ASH 25 M

Technical Note No. 15 **Alexander Schleicher**

Subject: Inspection and exchange of the exhaust damper of the power-plant. Amendment and

corrections to the manuals.

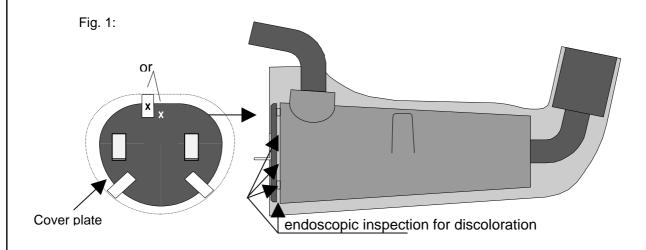
version of the exhaust damper has been installed. The upgraded exhaust dampers were marked with the letter 'X'. This marking is located on the front side as shown in Fig. 1:

a) Where an exhaust damper without this marking is still installed and if the operating time of this exhaust damper is less than 40 hours, then prior to the next take-off the CFRP fairing of the exhaust must be inspected for overheat traces while it is still installed.

Where the operating time of the exhaust damper is above 40 hours, the front side of the exhaust damper behind the cover plate (see Fig.1) must be additionally inspected for tempering coloration using an endoscope. If this inspection does not reveal any discoloration from the golden-yellow basic coloring changed to a gray or bluish coloration so, a further engine operation in another two hours intervals is allowed. This inspection must be repeated in 2 hours intervals up to a maximum operating time of the exhaust damper of 60 hours.

If damages or discoloration are found during any of the above inspections, the exhaust damper must be exchanged prior to the next engine flight.
